**SUBJECT:** Kittredge West and Kittredge Commons, Addendum #1  
University of Colorado

# **ADDENDUM #1**

## **University of Colorado Kittredge West and Commons Asbestos Abatement and Demolition Project CTL Project Number FC05461.001/.002**

Date of Addendum #1: August 9, 2011

**BASEMENT ABATEMENT**

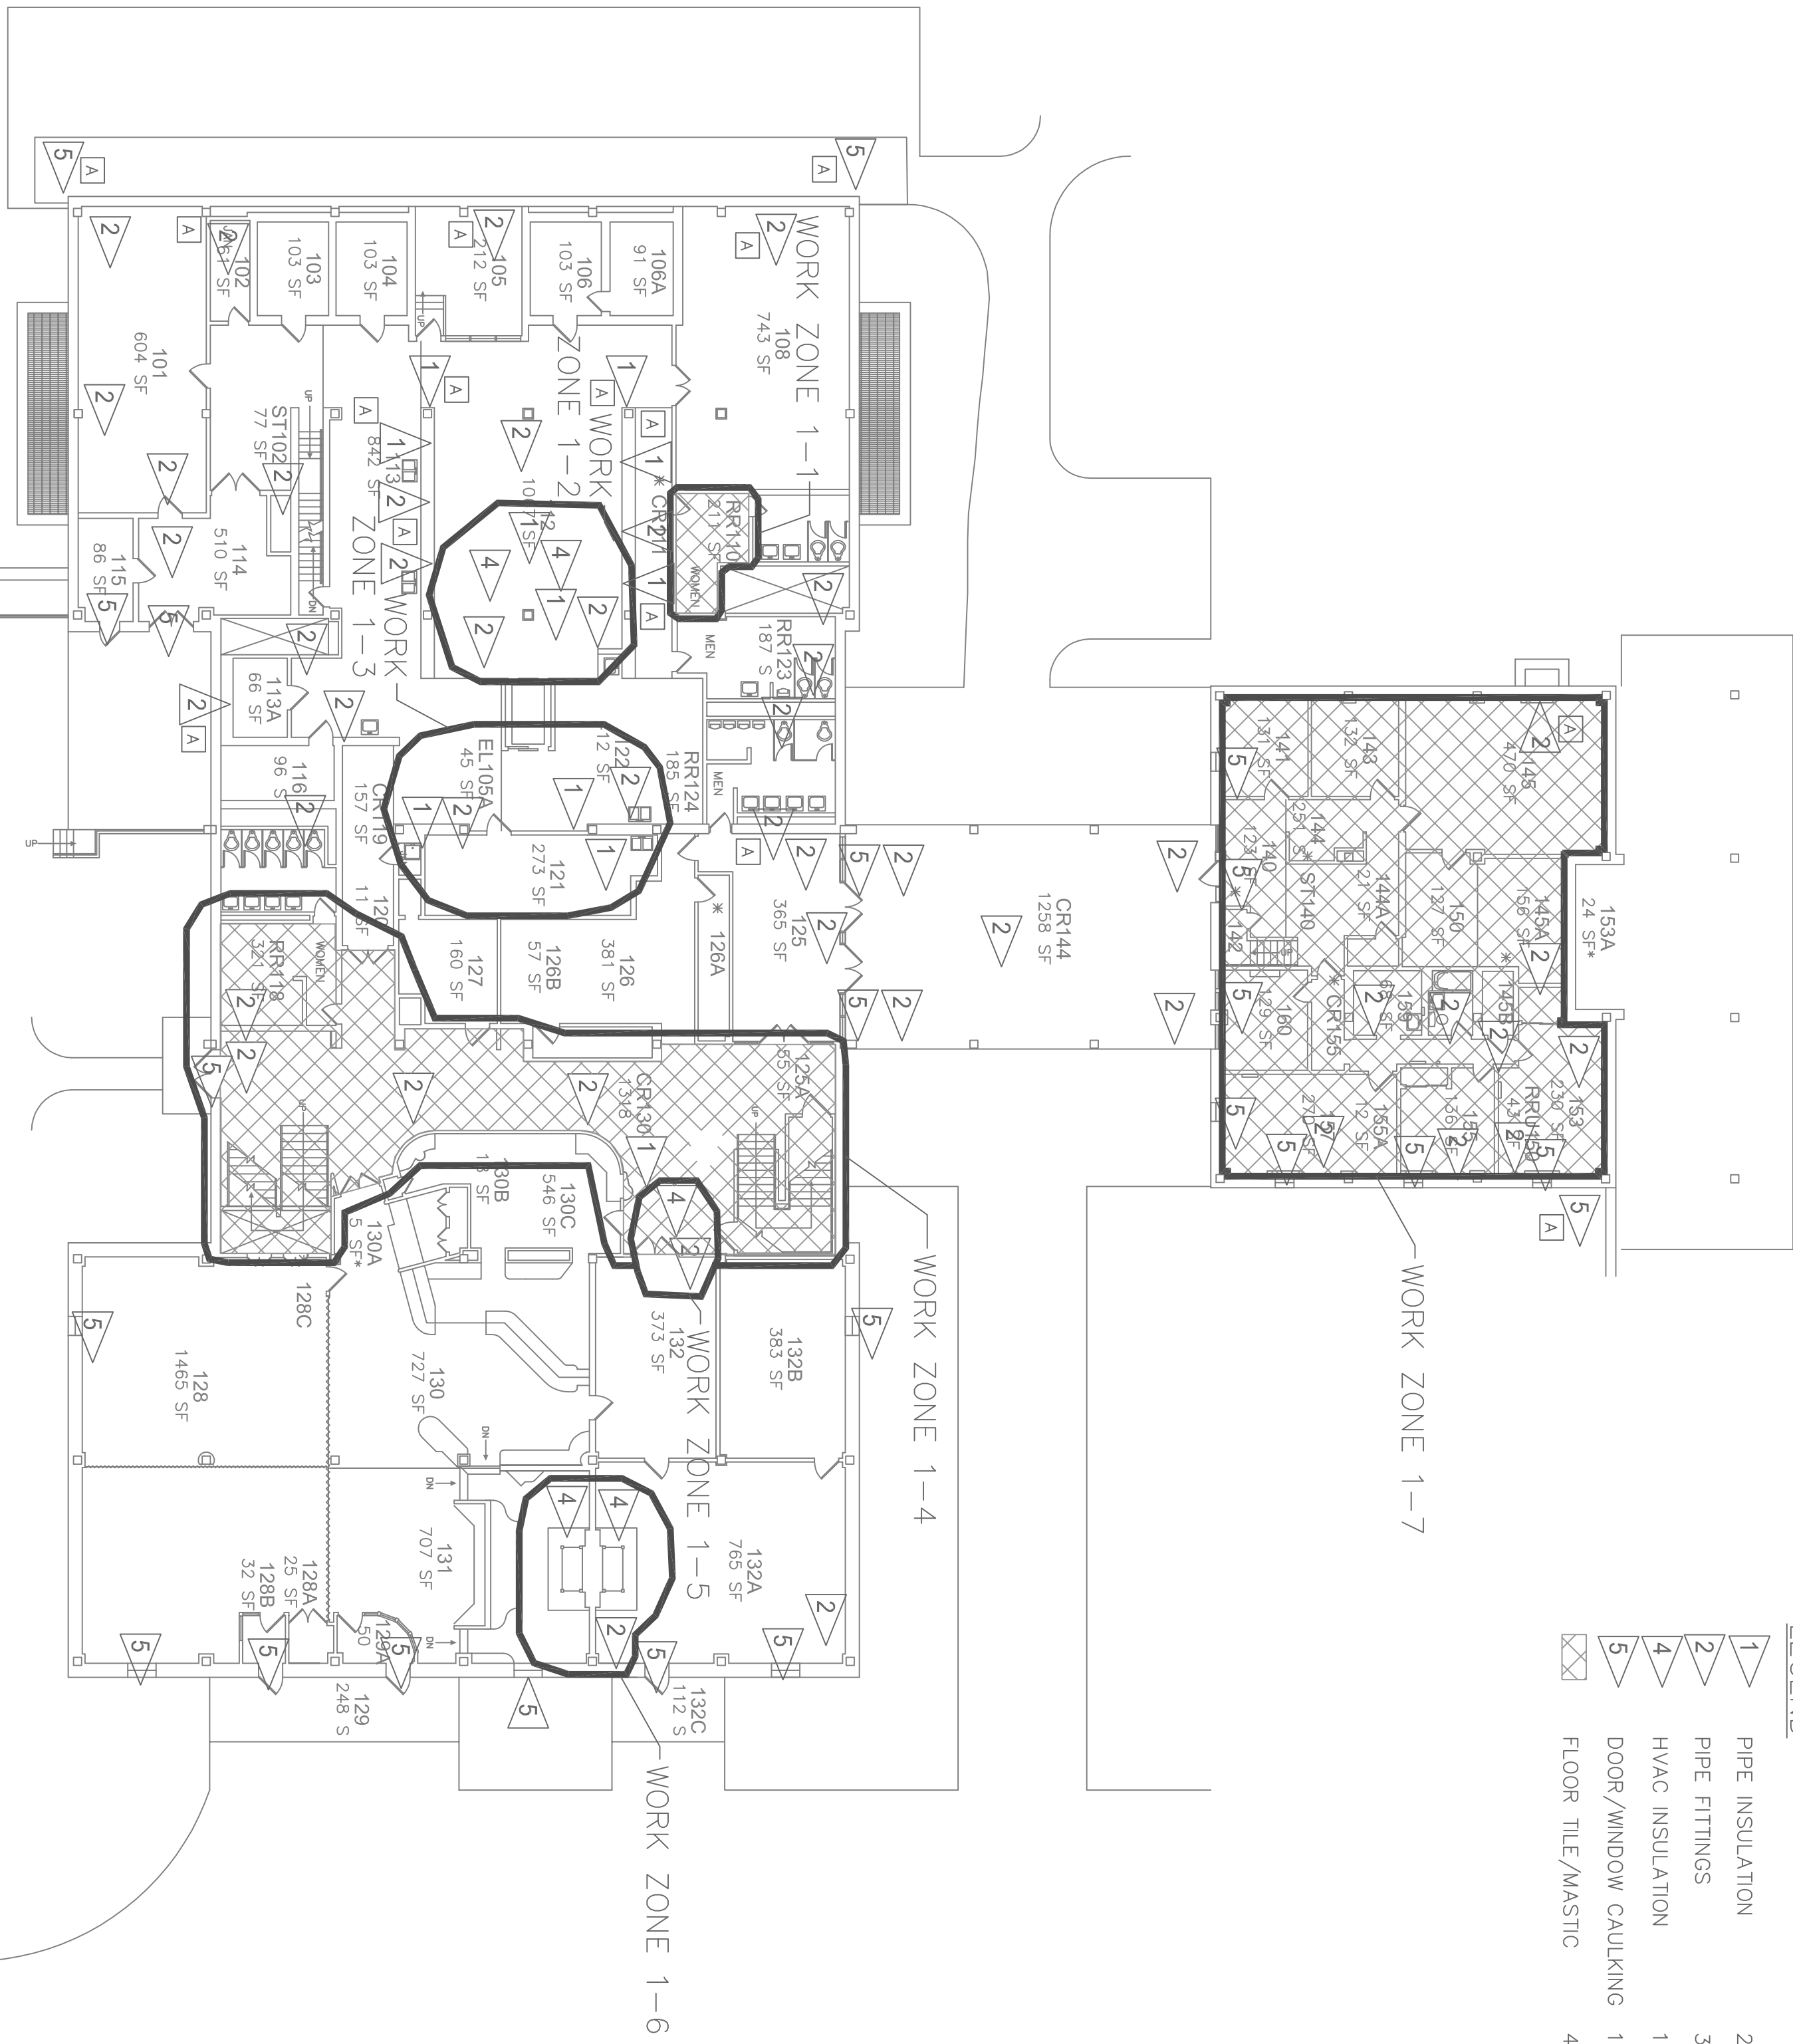
8. The following quantities have changed:
  - a. See revised drawings (attached)

PIPE INSULATION	250	LINEAR FEET
	PIPE FITTINGS	275	EACH
	FLEX CONNECTORS	2	EACH
	TANK INSULATION	110	CUBIC FEET

**FIRST FLOOR ABATEMENT**

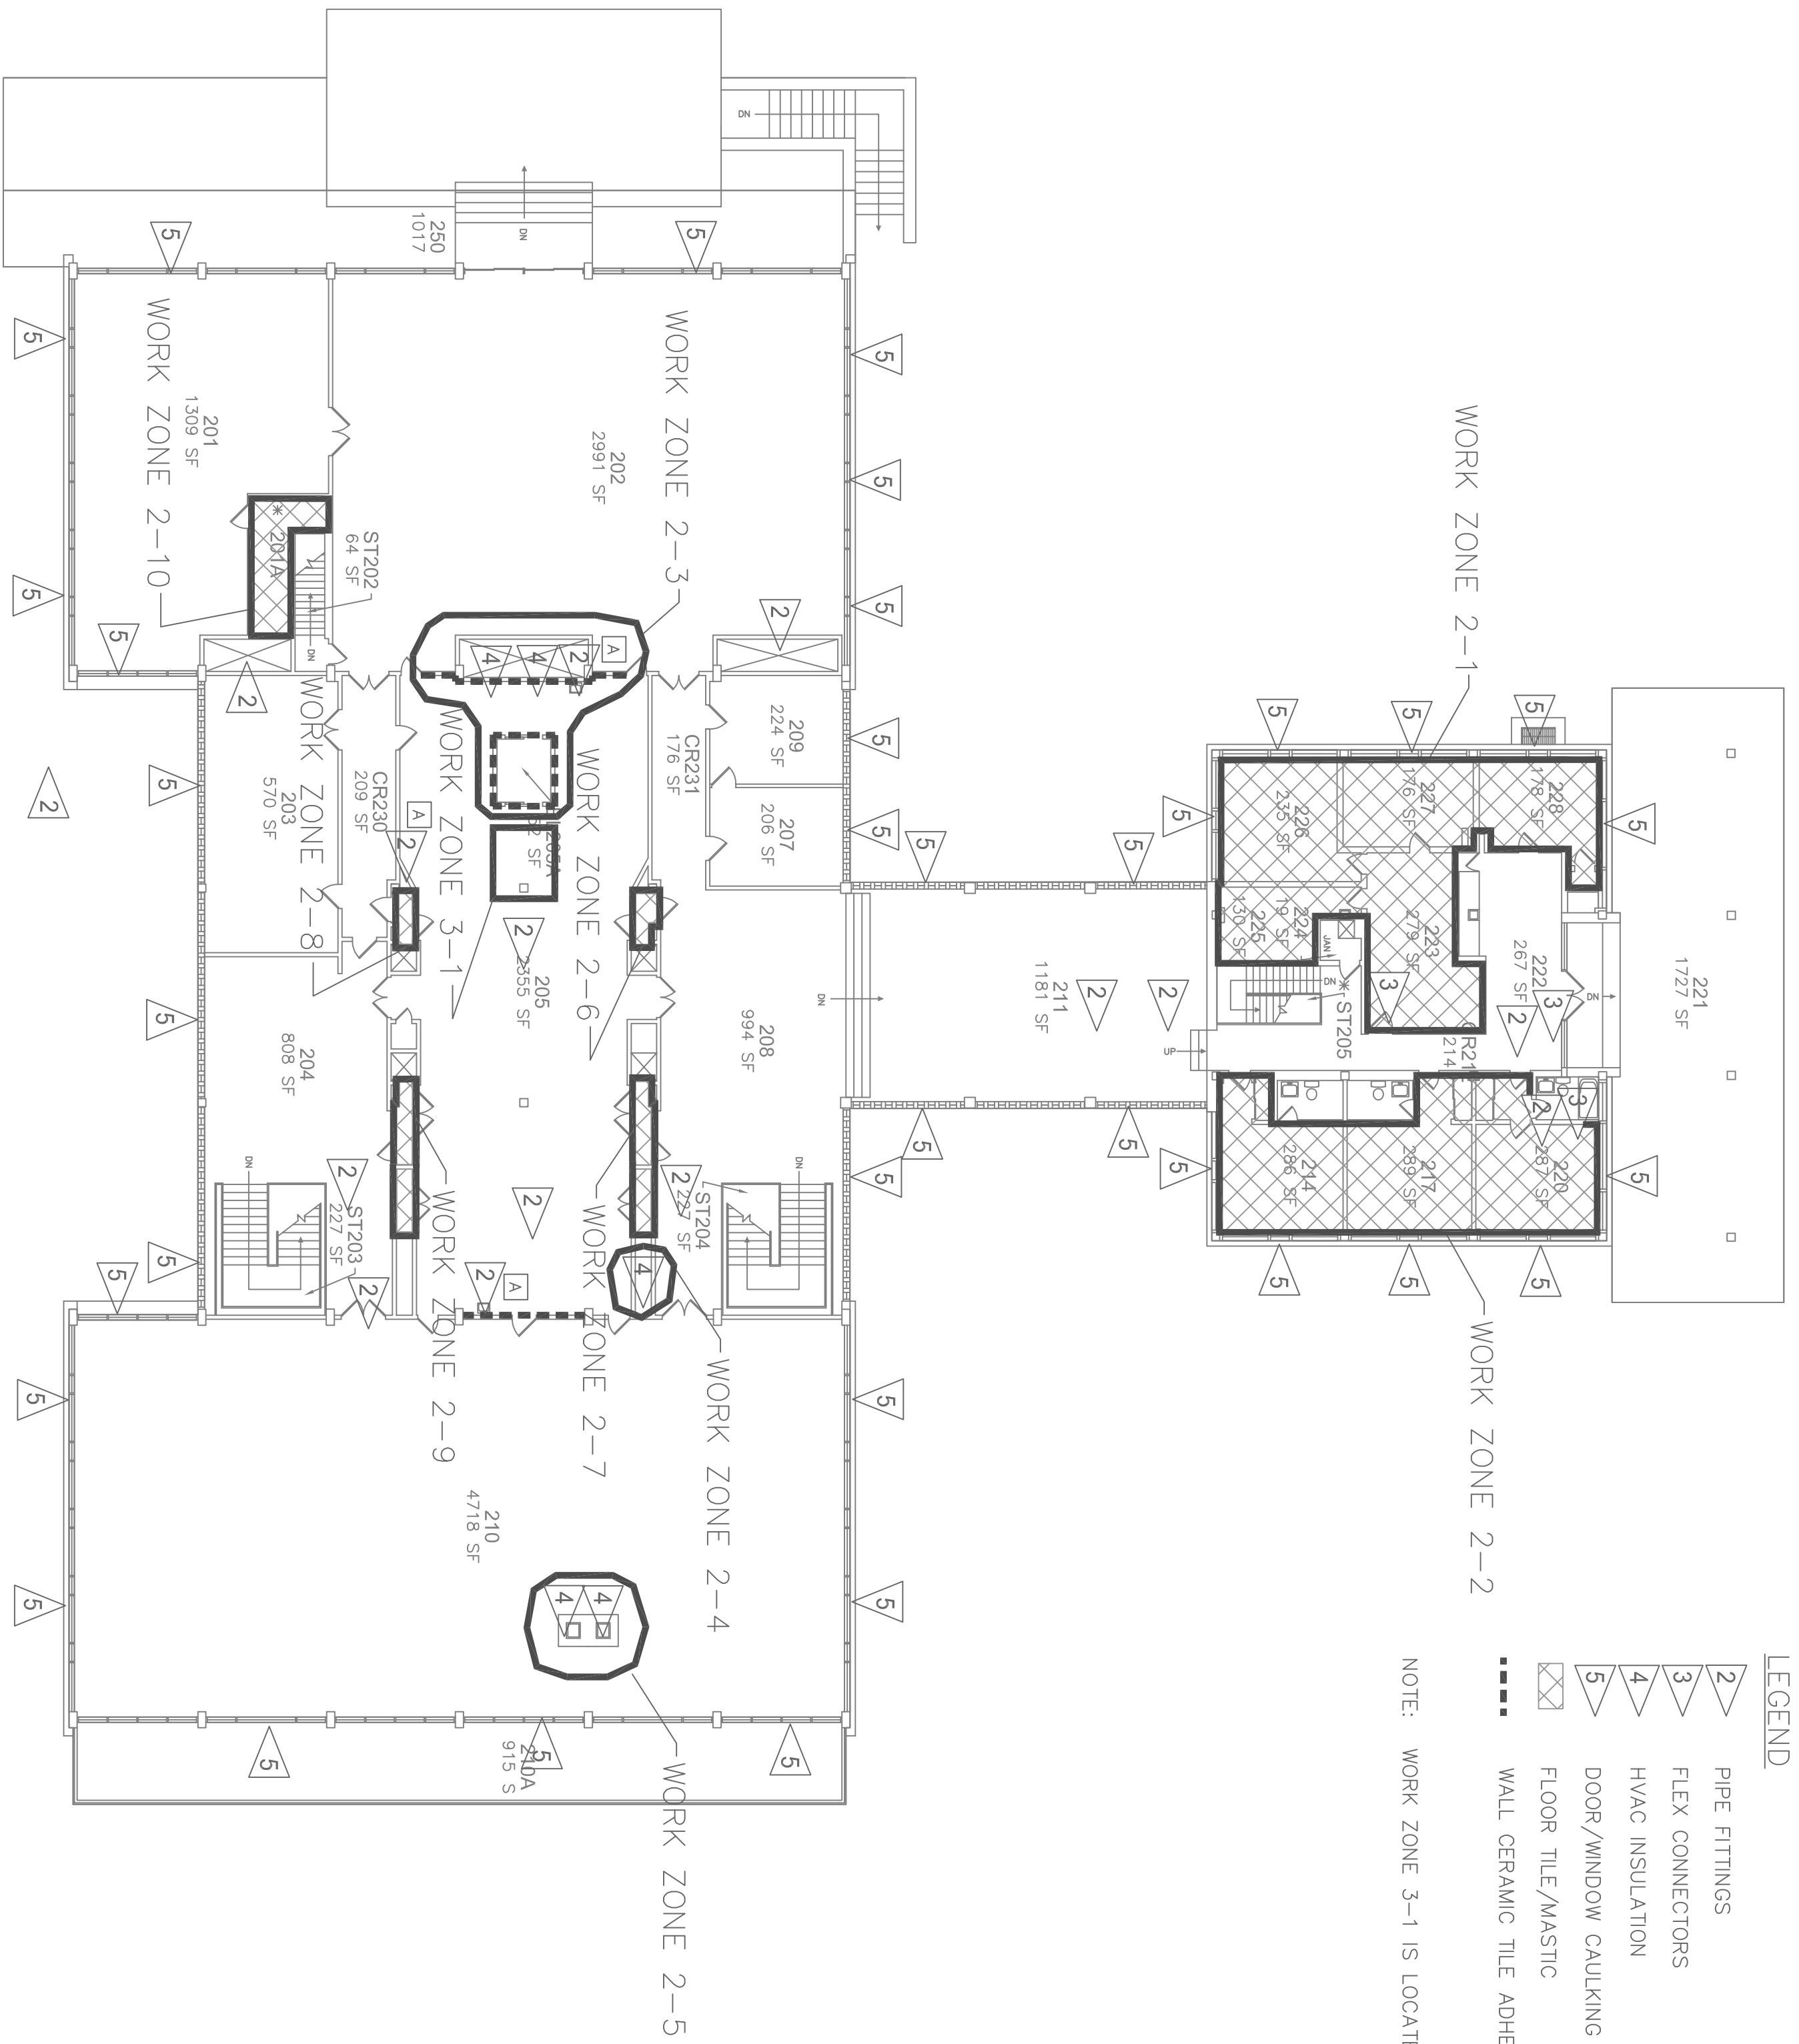
1	PIPE INSULATION	250	LINEAR FEET	A
2	PIPE FITTINGS	350	EACH	A
4	HVAC INSULATION	100	CUBIC FEET	A
4	DOOR/WINDOW CAULKING	1200	LINEAR FEET	A
5	FLOOR TILE/MASTIC	4620	SQUARE FEET	A
